Aiken Intermediate – Bus Transportation Office Aiken County Public School District

September 30, 2026

Addendum No. 01

A4.1

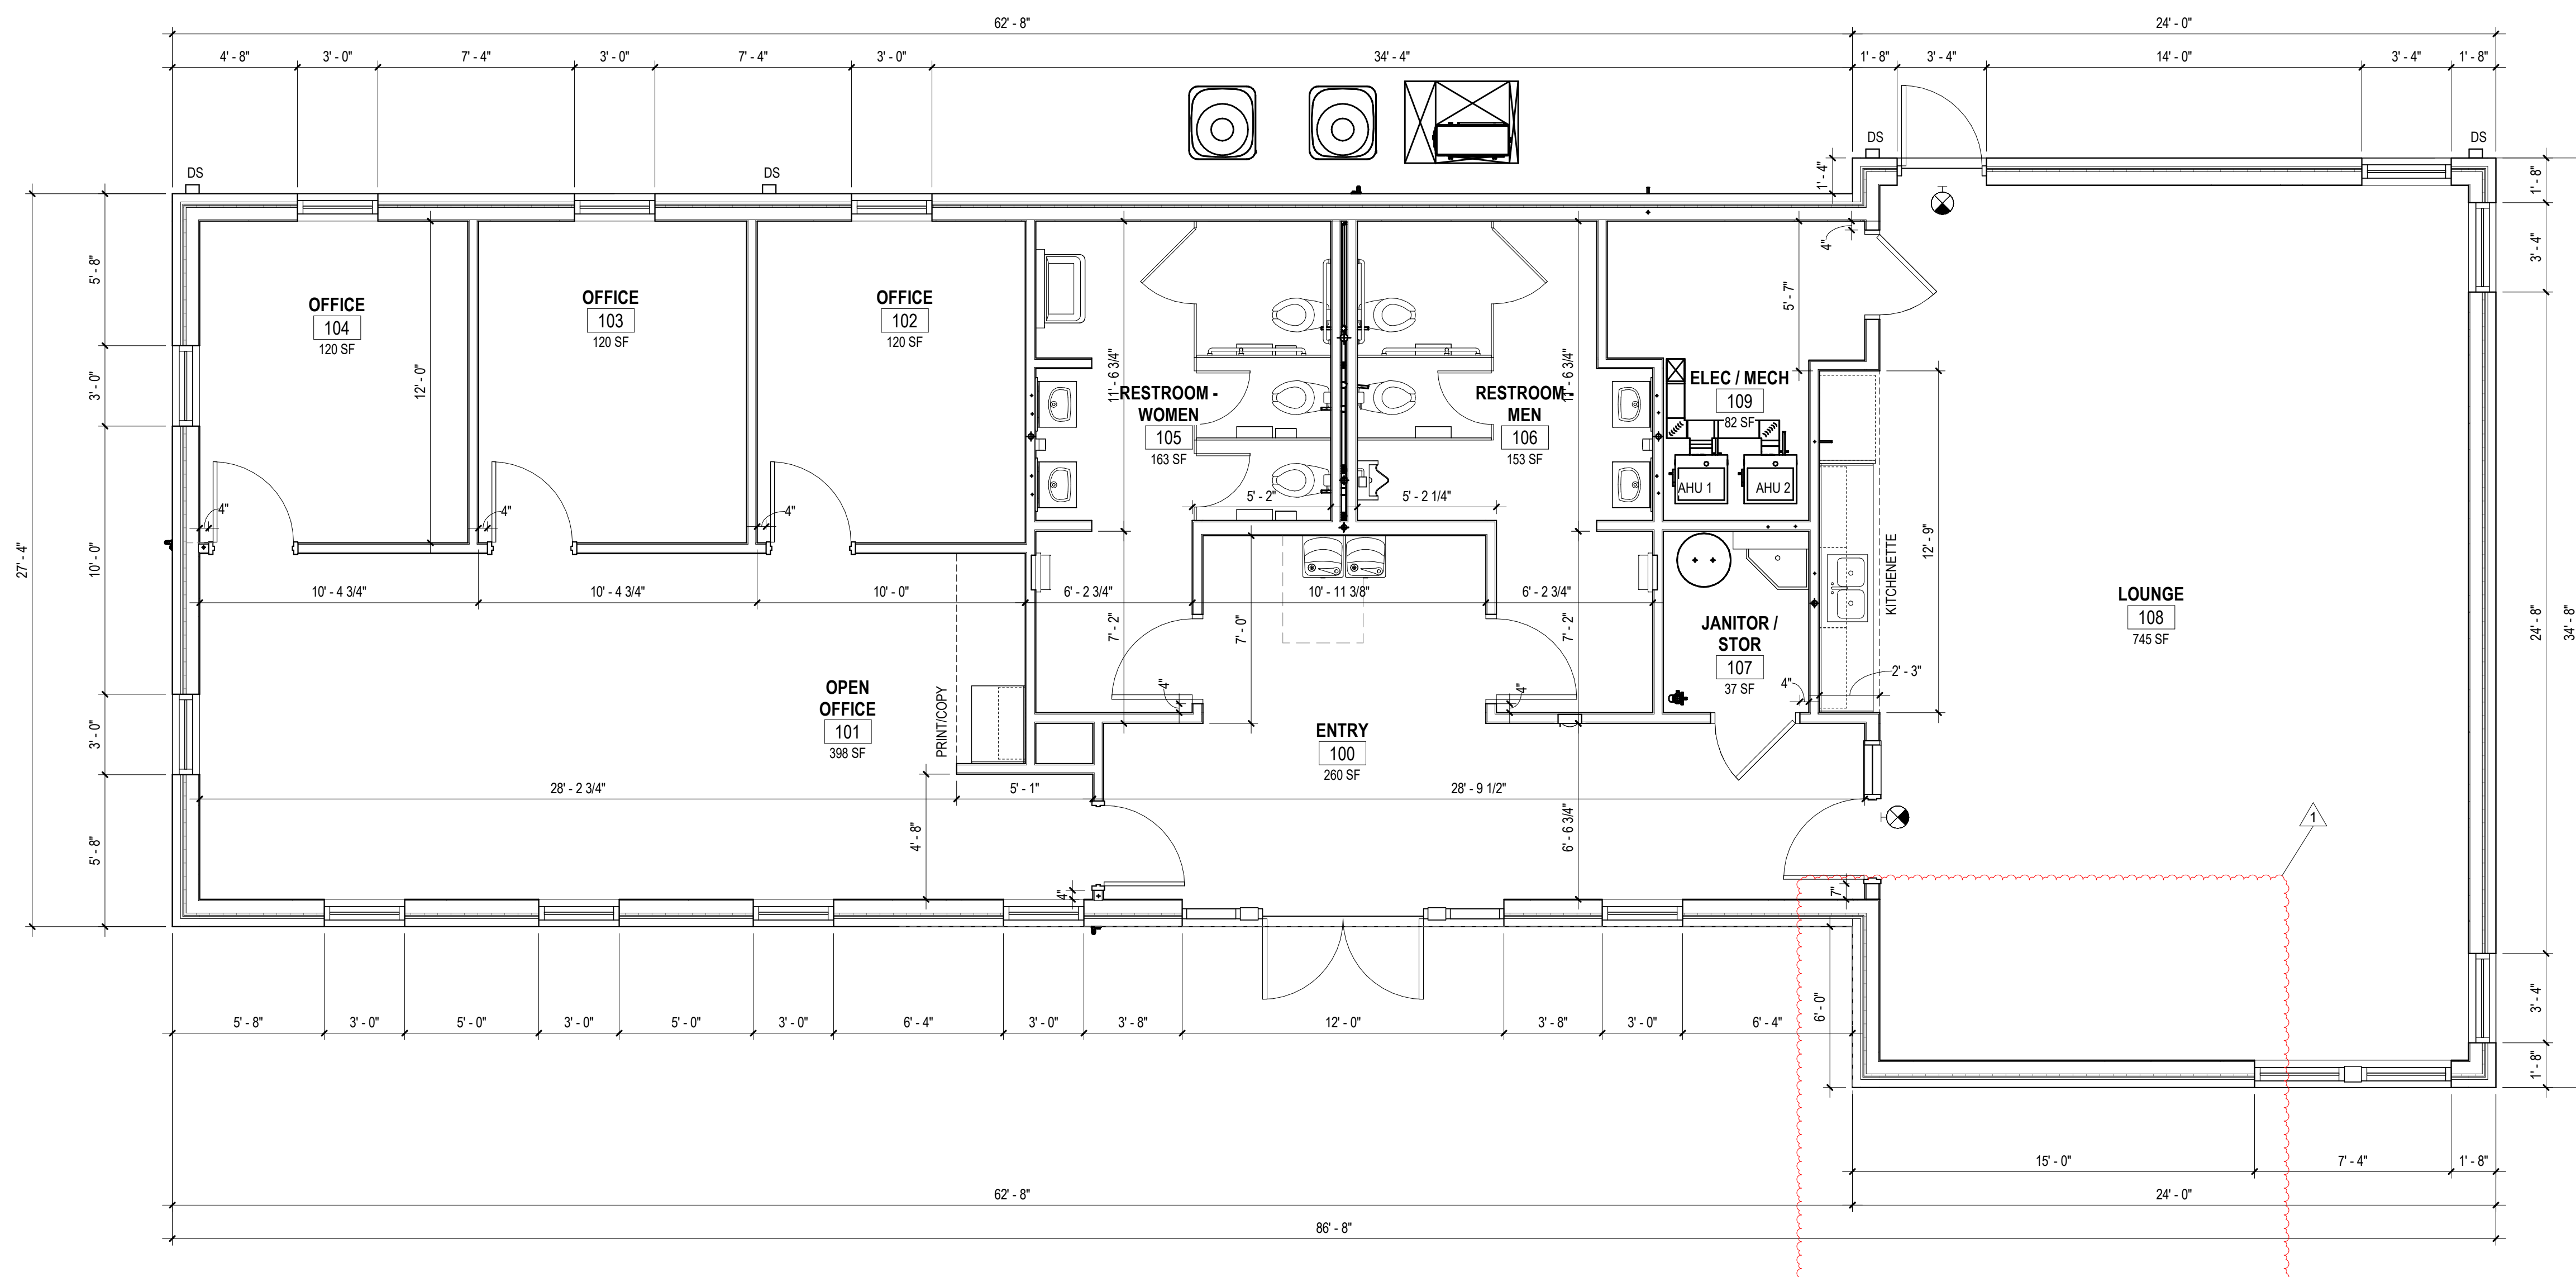
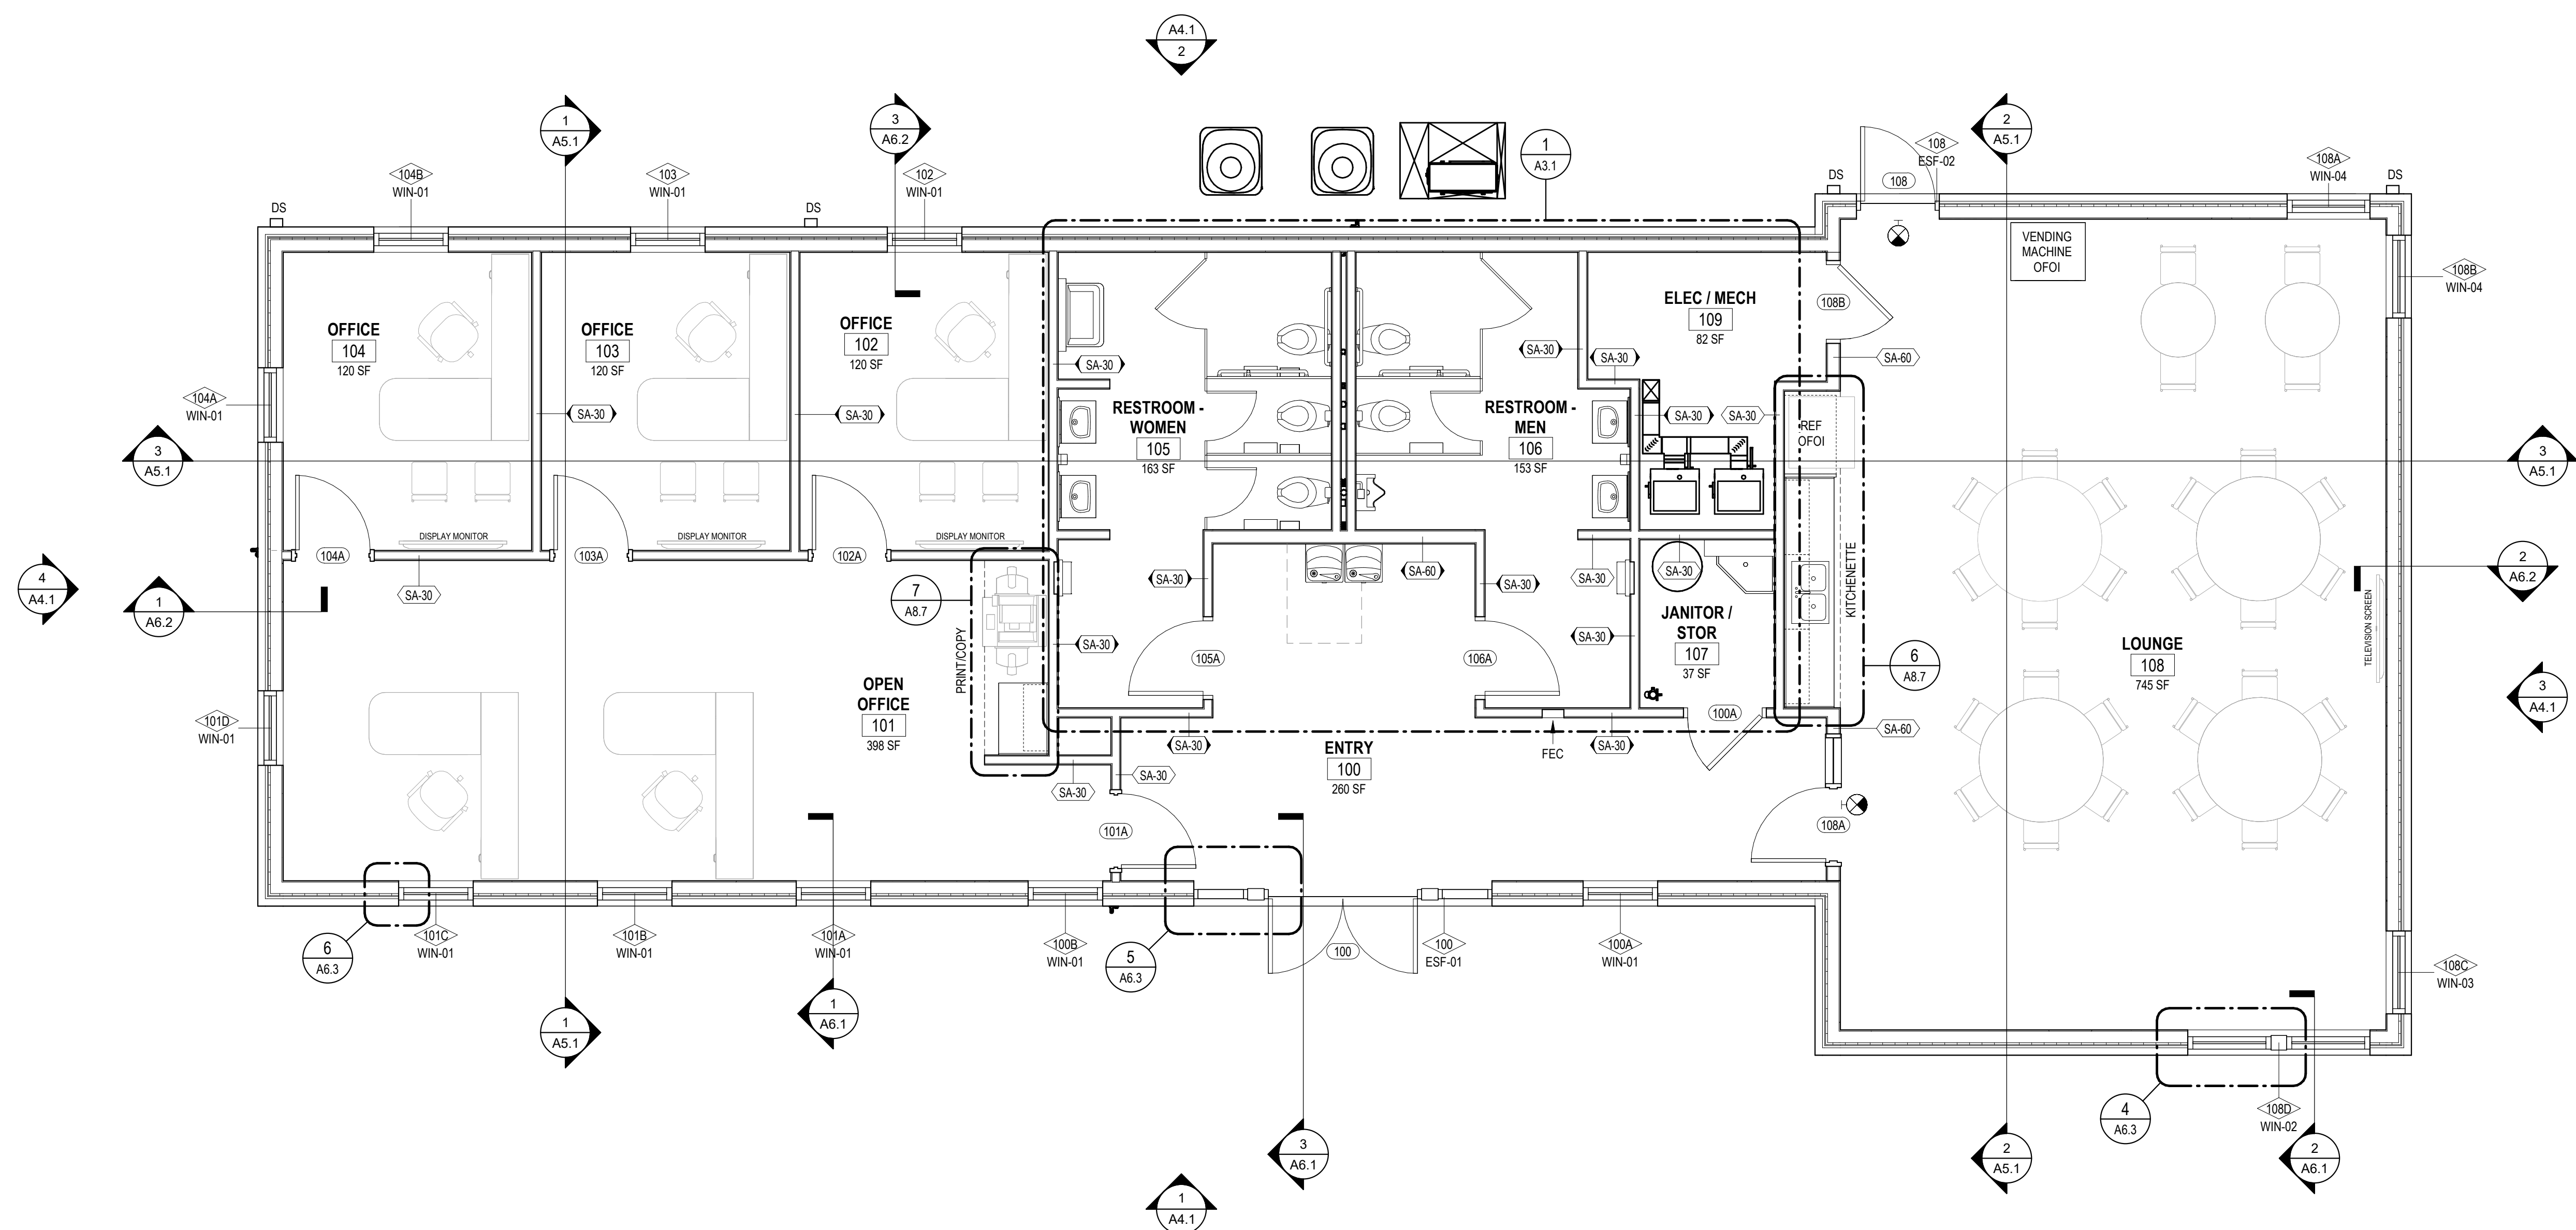
4. Drawing A4.1
 - a. See revisions regarding storefront finishes.
5. Drawing A8.1
 - a. See revisions to floor finish plan regarding CPT-1.

5. A4.1 contains both white painted finish and dark bronze requirements for storefront windows. Confirm finish.

All exterior storefront windows and doors shall be white. Please see revised A4.1 attached.

1 FINISH PLAN - FIRST FLOOR
A8.1 1/4" = 1'-0"

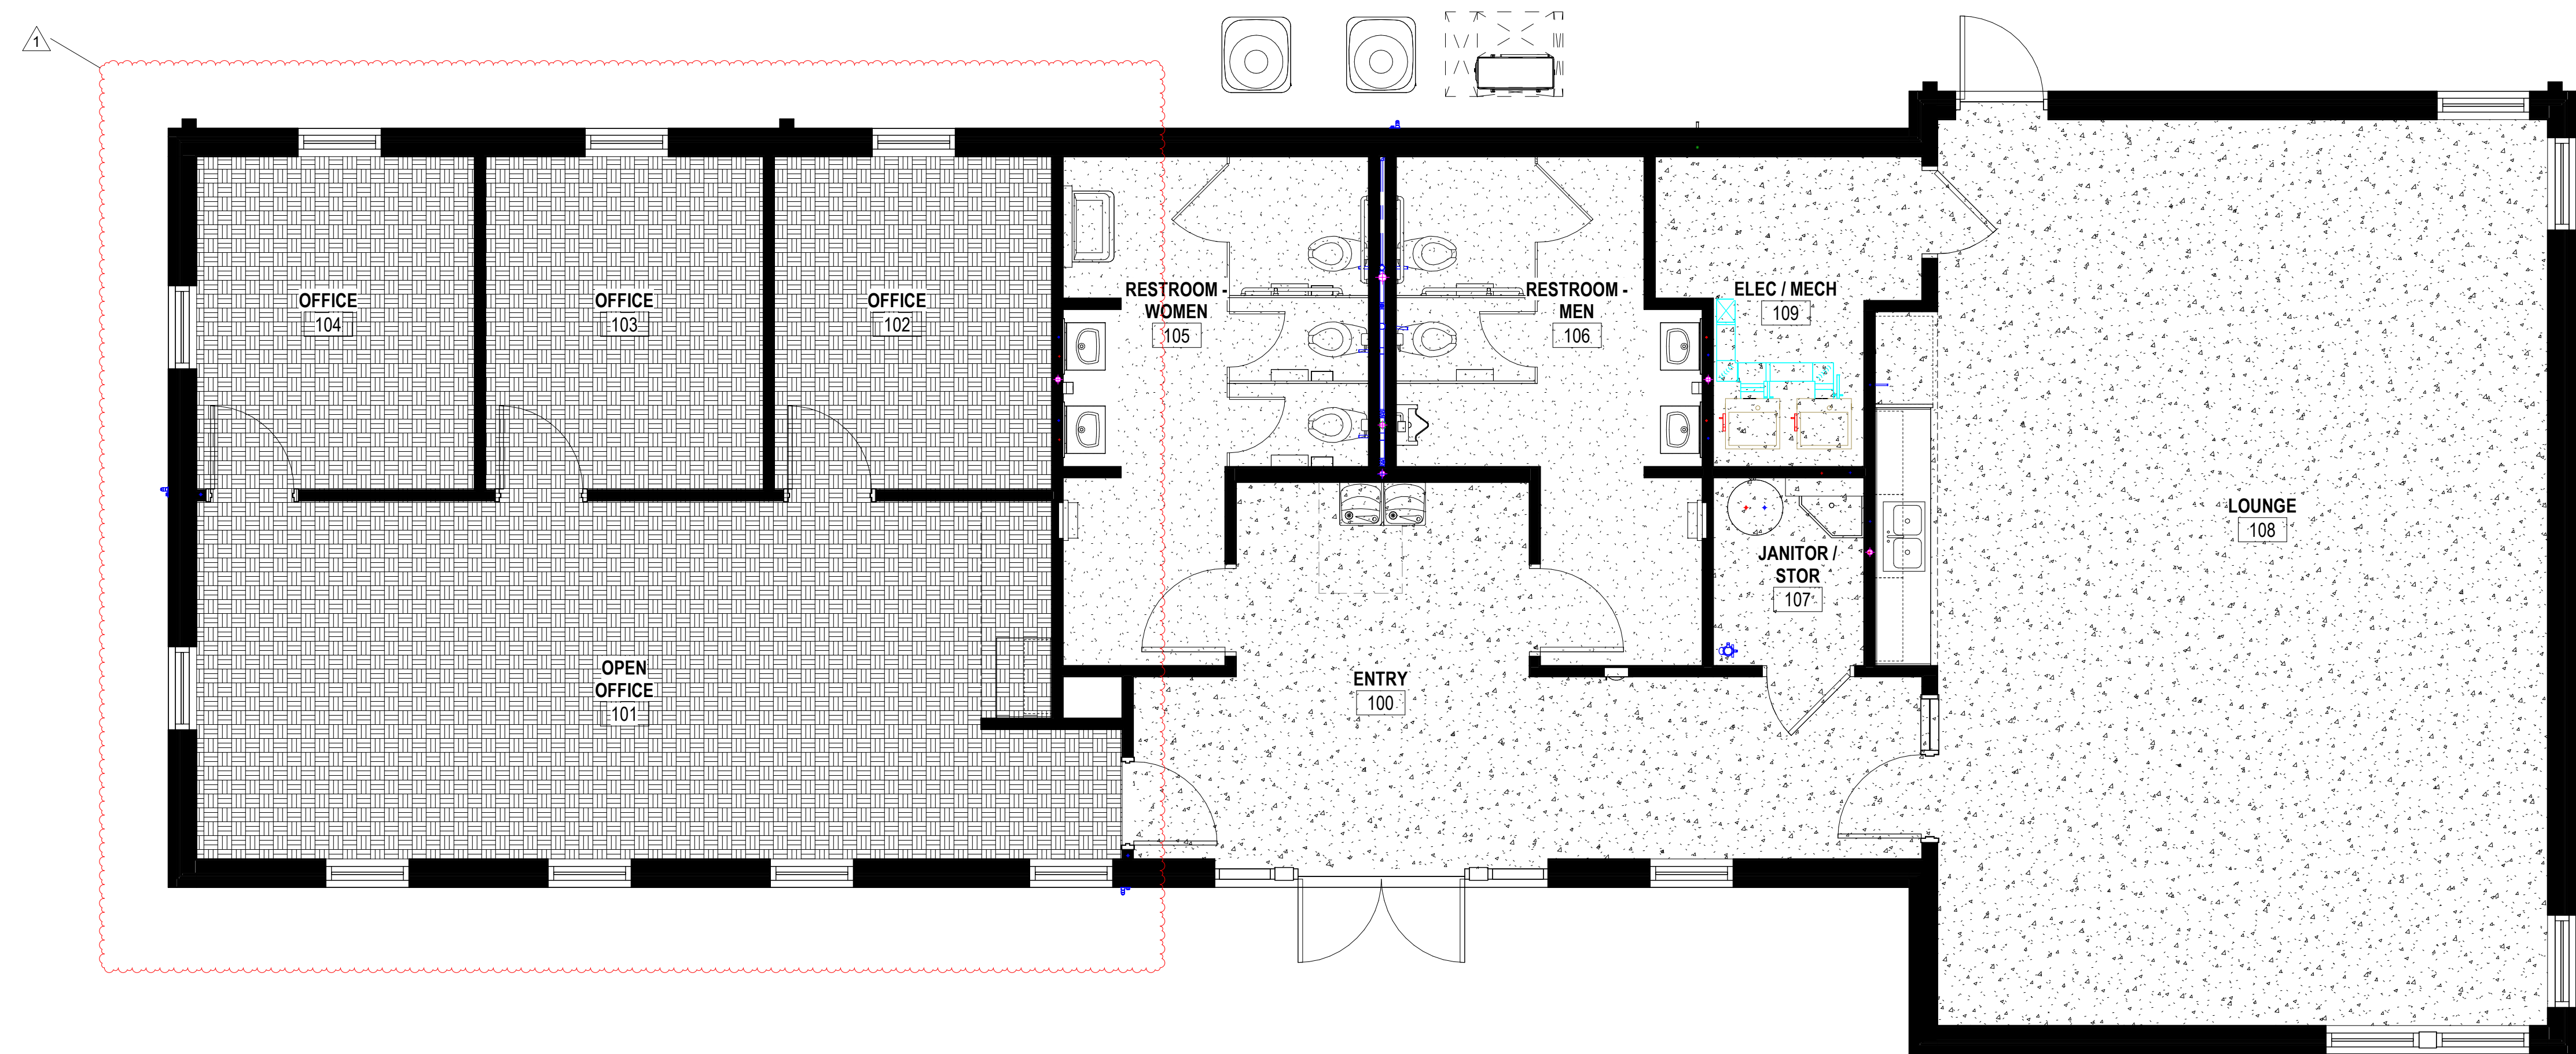
1. Open Office 101: A8.1 schedule specifies CPT-1 carpet, while the revised plan hatch indicates sealed concrete. Confirm the finish.

Open Office 101 is to receive CPT-1. Please see the attached revised drawings for reference.
